30012599 – 416 Berrima Road Hydraulics-Variation 01
13 October 2020

RE: 416 Berrima Road -DPIE RFI Responses

Figure 1. 1%AEP Afflux for the proposed development

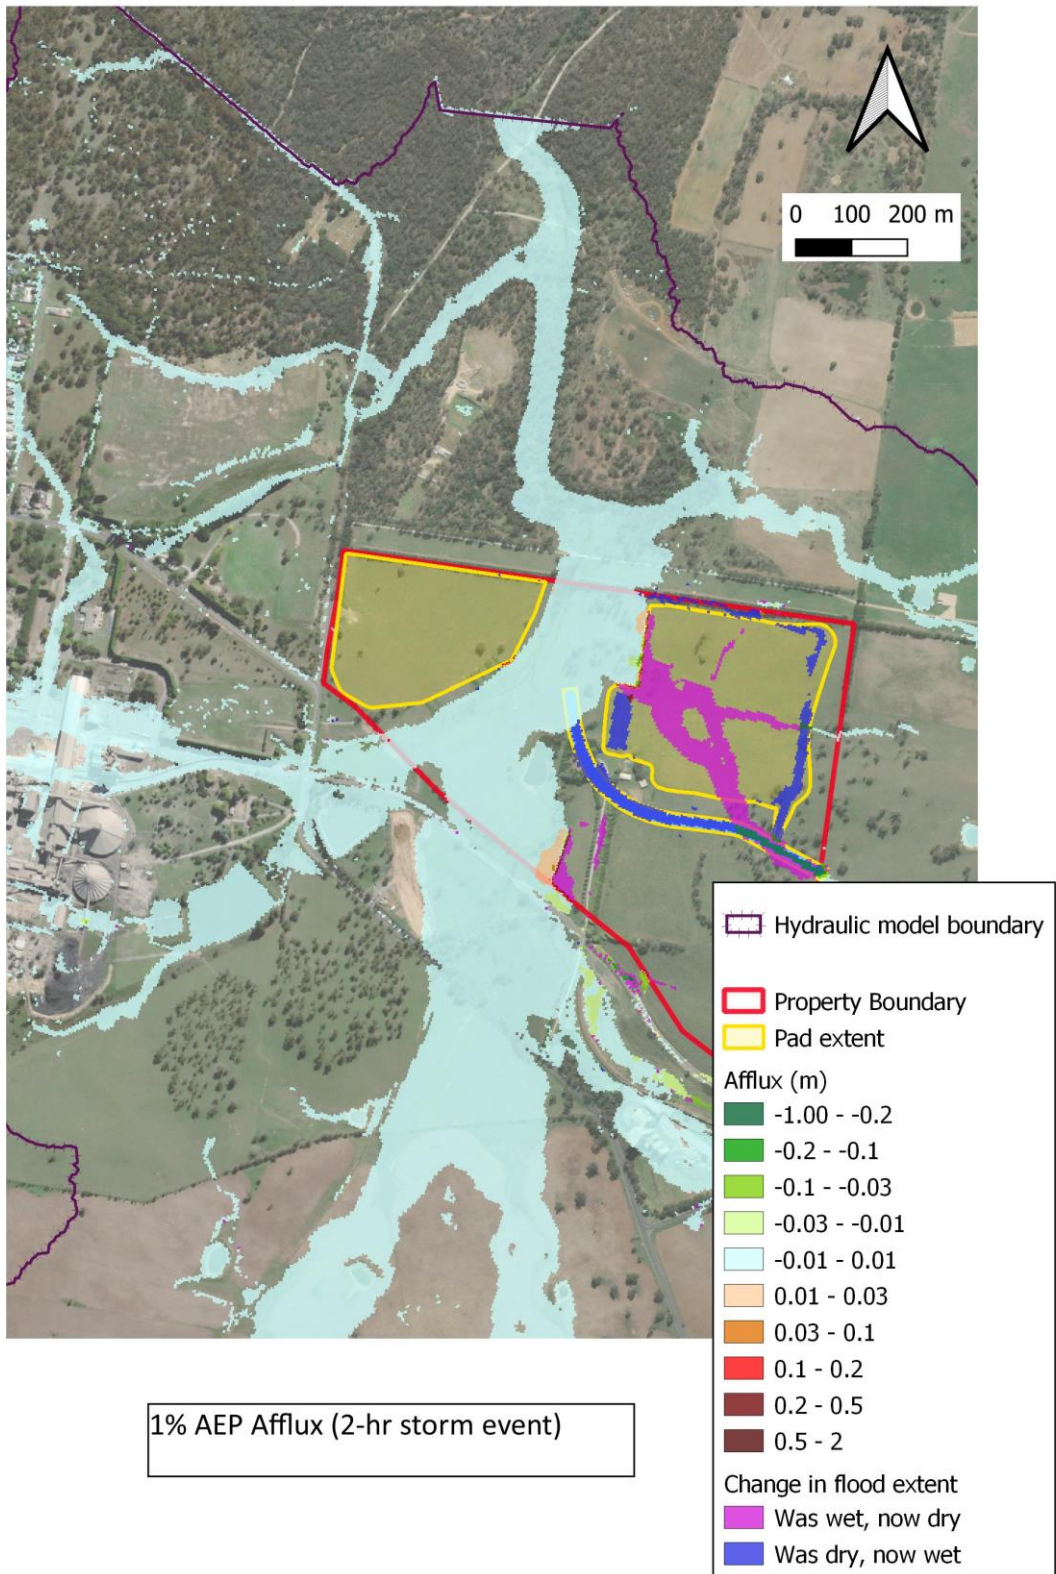
This letter covers the tasks outlined in the approved proposal, dated 1 October 2020, to address Department of Planning and Environment (DPIE)'s comments related to "Flood Impact Assessment Report for New Berrima Brickworks Facility at 416-524 Berrima Rd, moss Vale" dated 9th March 2020.

As it can be seen in Figure 1, the modelling indicates that the proposed developments (delineated in yellow) will have no or negligible flood impact (up to 10mm increase in water level) on Stony Creek flood levels under the 1% AEP storm event. The results indicate that flood levels within Stony Creek are not impacted by the development.

Furthermore, As shown in Figure 1, the proposed development discharges to Stony Creek only, and there is no direct discharge from the development into the Wingecarribee River.

Figure 2. Flood depth 1%AEP storm event (Wingecarribee River Flood Study 2014)

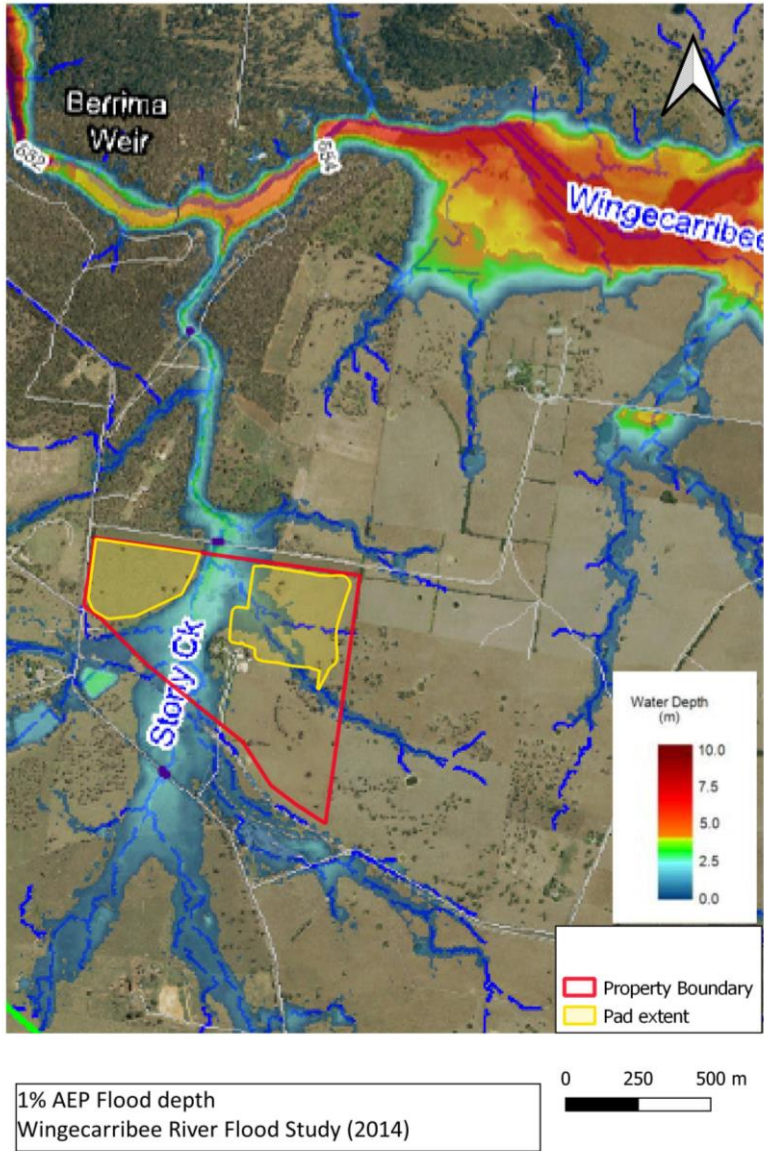
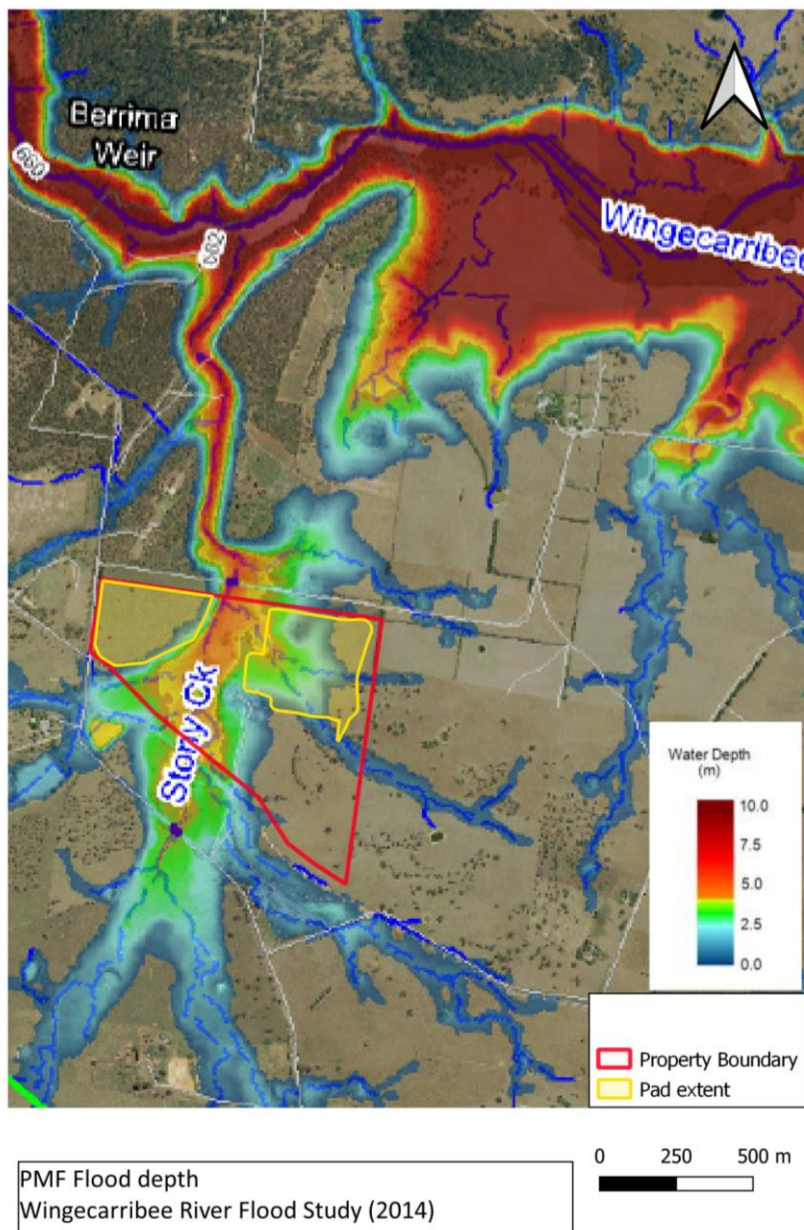
It supports the previous submission and further addresses DPIE's comments regarding potential flood impacts from/to the Wingecarribee River associated with the proposed development.

As shown in Figure 2 and Figure 3, Wingecarribee River mainstream flooding does not affect the site under 1% AEP and PMF storm events. Furthermore, there is no direction interaction between Wingecarribee River mainstream flooding and Stony Creek flooding near the site.

Also, a review of the available digital elevation model (2m grid LiDAR data obtained from Elevation Foundation Spatial Data by NSW Government) shows that Stony Creek invert level (RL 657m AHD) is approximately 10m higher than the invert level (RL 647m AHD) of Wingecarribee River at the confluence point. Whilst, the minimum elevation for the site under the existing condition is about 660m AHD. This shows that mainstream flooding from the Wingecarribee River only would affect the proposed development if water depth reached 13m which is not the case as shown in Figure 2 and Figure 3.

Hence, the site including the proposed development is not affected by Wingecarribee River mainstream flooding under 1% AEP and PMF events.
